# A6027 De Havilland Way Corridor Scheme

Consultation Summary Report

Bolton Council

## Response to the consultation on the De Havilland Way LUF proposal

Figure 4: Beehive junction design from the online consultation.

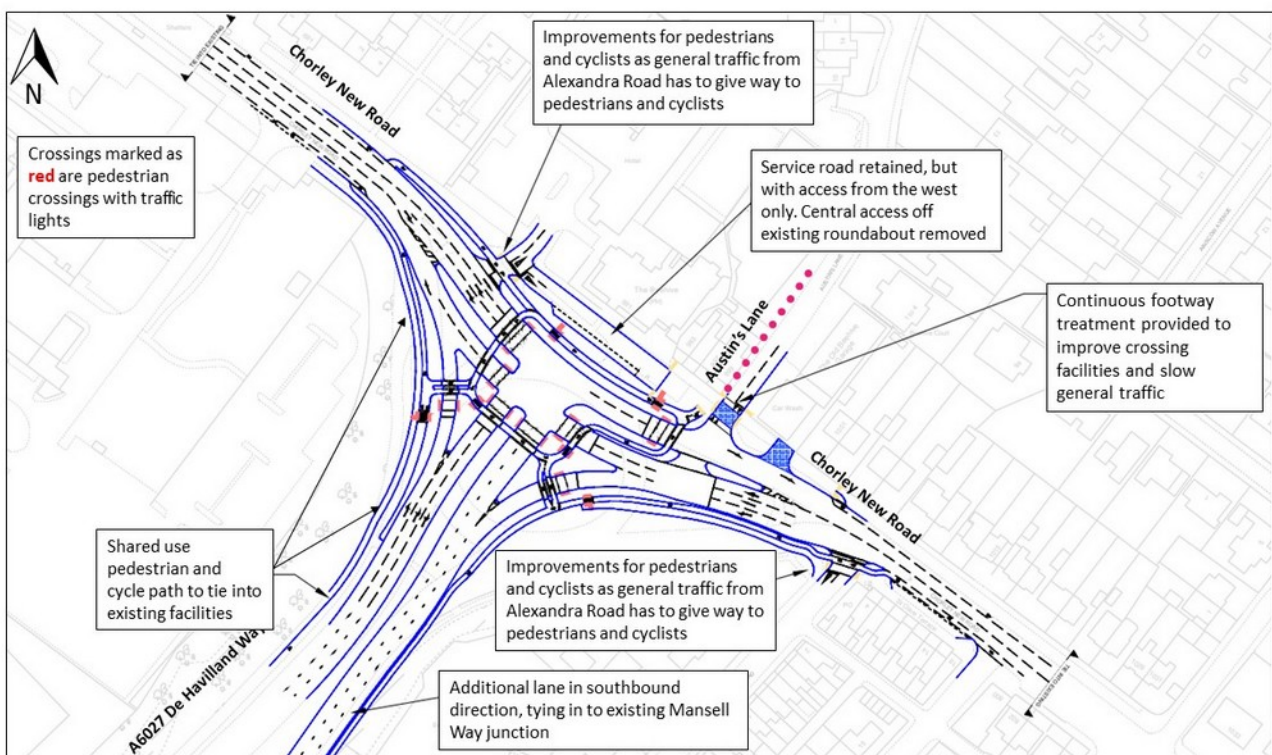
The drawing provided (see figure 4) shows an extended “cyclops junction” design including crossings with tactile paving for people to walk across the cycle lanes, and “sparrow crossings” to allow people walking and cycling to get across the left turn lanes that go onto and off De Havilland Way. The text in the label on the left with the three arrows, however, states that these are “shared use pedestrian and cycle paths”, at least on the western corner. For the purpose of this review, we

have assumed that kerb-protected cycleways are proposed in line with the drawn elements rather than the text.

The junction design shown on the drawing at Austin’s Lane is labelled as a continuous footway, but the drawing shows a raised table, not a continuous footway. The same error appears in the example image shown in the section of the web site about Austin’s Lane, which shows a raised table side road treatment, not a continuous footway.

We are concerned that the narrow advisory cycle lane through the door opening zone of parked cars on the westbound carriageway of Chorley New Road approaching Alexandra Road appears to be retained. This is already a dangerous arrangement that is best avoided altogether by anyone approaching the junction on a cycle. This will also make it difficult to enter the cycleway when approaching the junction from the east along Chorley New Road.

Figure 6: Spirit of Sport junction design from the online consultation.

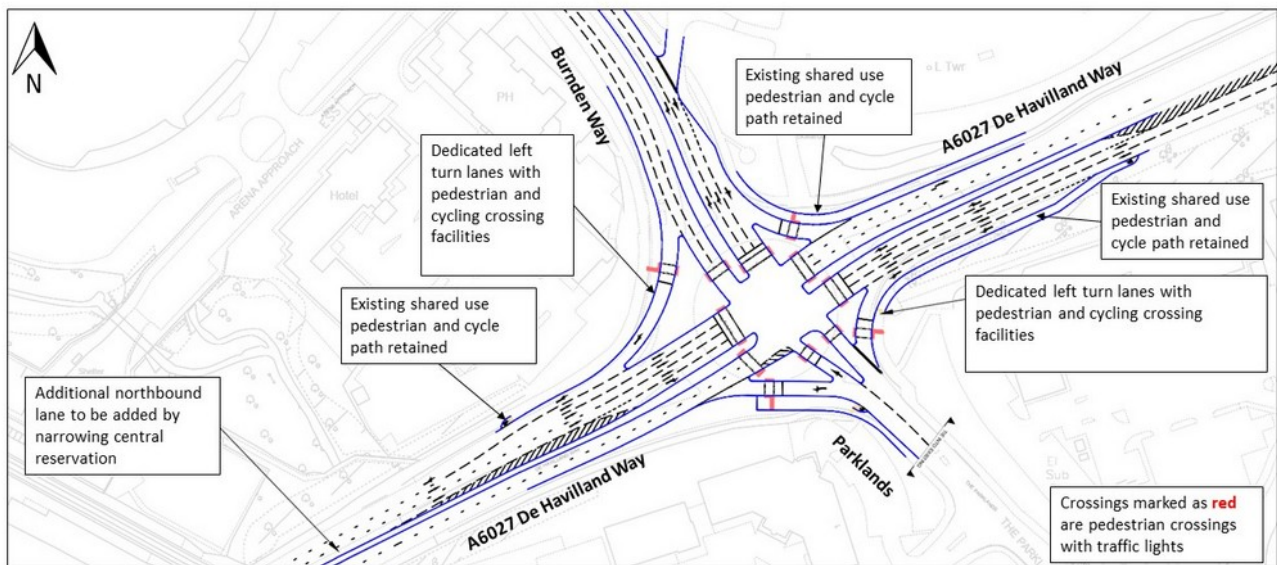
It is disappointing to see a much less ambitious design for this junction. The use of shared footways, and the geometry of the walking and cycling facilities suggest that the council's ambition is for only very small numbers of people walking or cycling here. This is particularly disappointing given that this junction will be a main walking and cycling access route for Horwich Parkway railway station. Increased use of this railway station, coupled with the use of active travel means to get to it, should be a major element of the council's plans for reducing road congestion across the area as well as on De Havilland Way itself.

The plan makes repeated reference to "existing shared use pedestrian and cycle path retained". However, it will be necessary to upgrade and resurface these for the same reasons as set out in Section 6.1 regarding links between junctions. As they currently stand they are unlikely to comply with LTN1/20.

It is not clear what provision, if any, will be made for walking and cycling on the south side of De Havilland Way to the west from this junction to the M61 junction. (See Section 9)

Figure 7: M61 Junction 6 design from the online consultation.

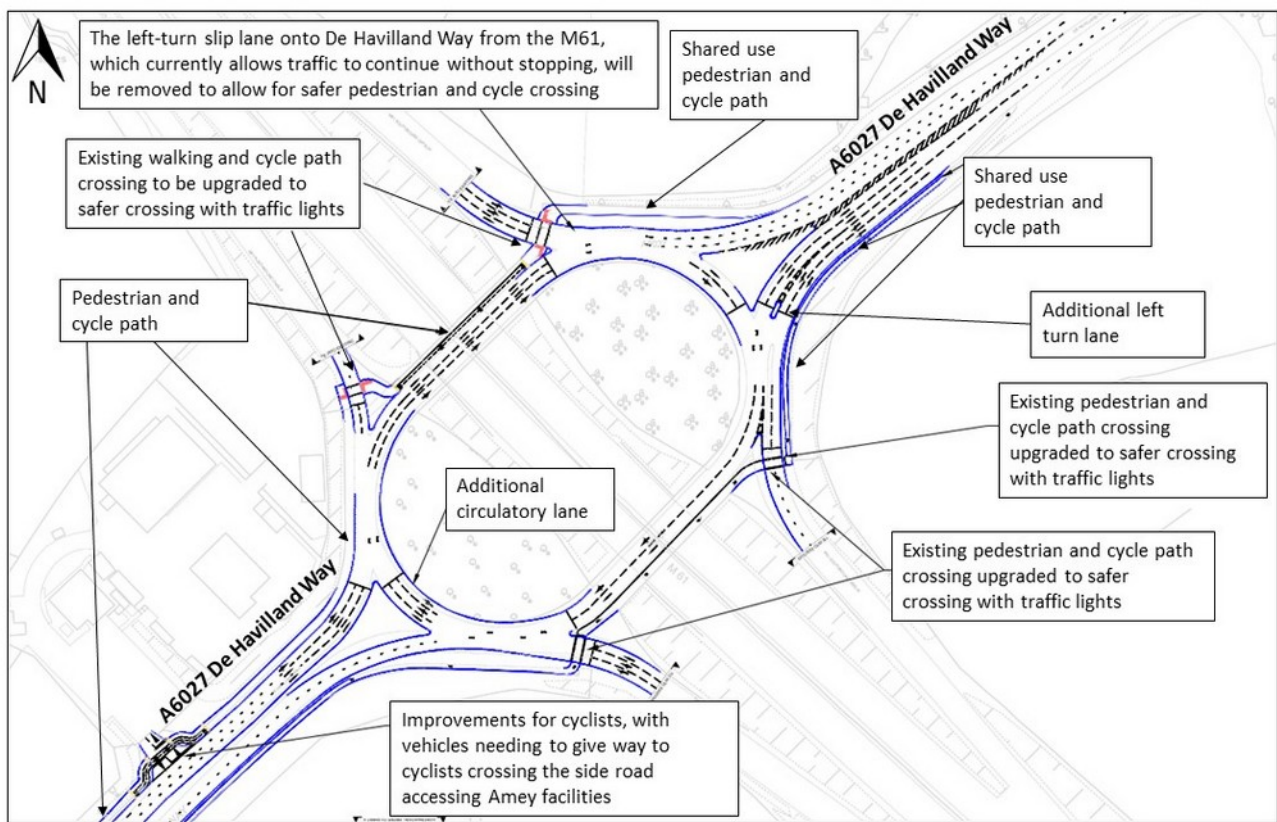
This design represents a vast improvement on the existing layout. We are particularly pleased with the signalization of the crossings, which are currently extremely dangerous with poor sight lines when crossing very fast motor traffic lanes, and simplification of the exit slip roads from the motorway, which currently suffer from inadequate cycle waiting space on refuges.

We are also pleased to see the improvement to the access road for Amey, which will reinforce the existing priority for people walking and cycling over motor vehicles entering and exiting the site. Consideration should be given to ensuring that motor vehicles entering the site have sufficient space to wait without blocking the carriageway on De Havilland Way as that would help to remove some of the pressure on drivers to fail to give way.

We are concerned that it is not clear what provision, if any, will be made for people approaching this junction on foot and cycles from the north-east along De Havilland Way. (See also Section 8) The arrangement shown in the drawing is just the existing provision, which requires cyclists to approach on the main carriageway.

We note that an additional lane has been introduced on the north-west side of the roundabout. This should not result in a significant reduction in the width of the shared walking and cycling path there. This is particularly important here as the route tends to be treated as two-way by people cycling.

Figure 8: A6 Chorley Road junction design from the online consultation.

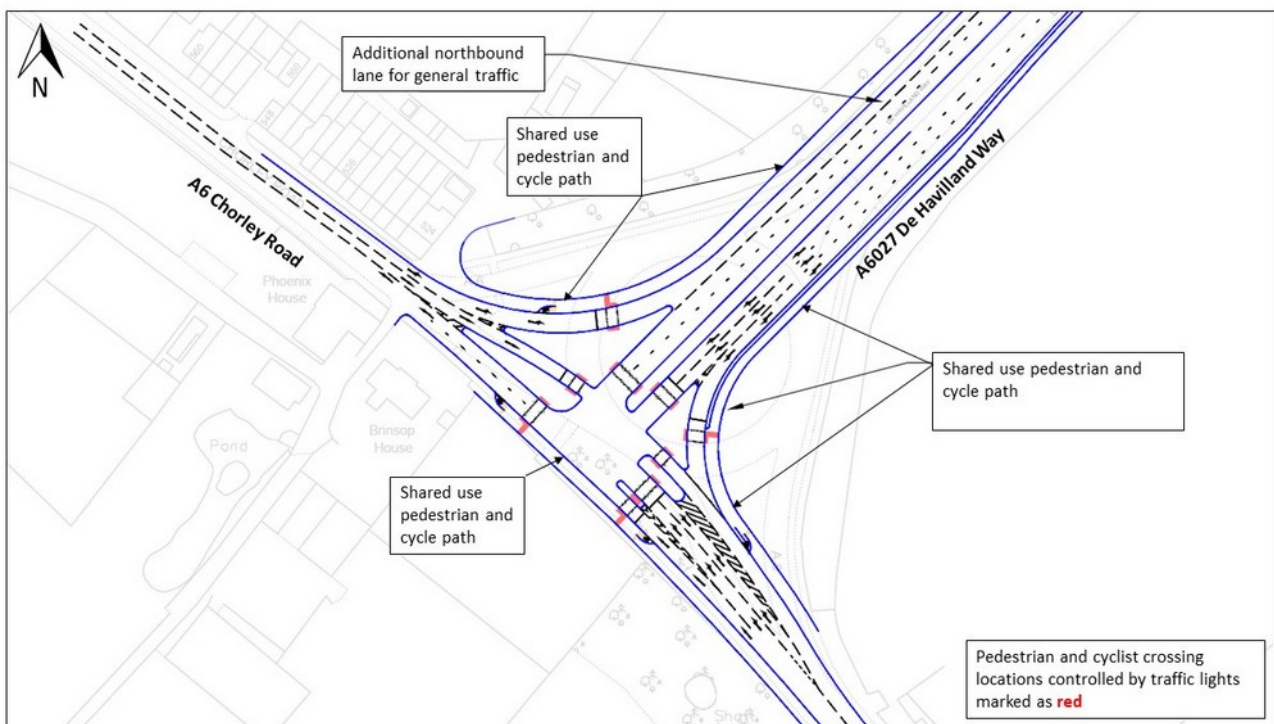
Our comments on this junction are similar to those on the Spirit of Sport junction (Section 8). The use of shared footways, and the geometry of the walking and cycling facilities suggest that the council's ambition is for only very small numbers of people walking or cycling here. This is particularly disappointing given that this junction will be a main walking and cycling route between Westhoughton, Aspul and other areas, and Horwich. Increased use of cycling particularly for intermediate distances such as this, including access to the railway station for people wishing to travel north, should be a major element of the council's plans for reducing road congestion across the area as well as on De Havilland Way itself.
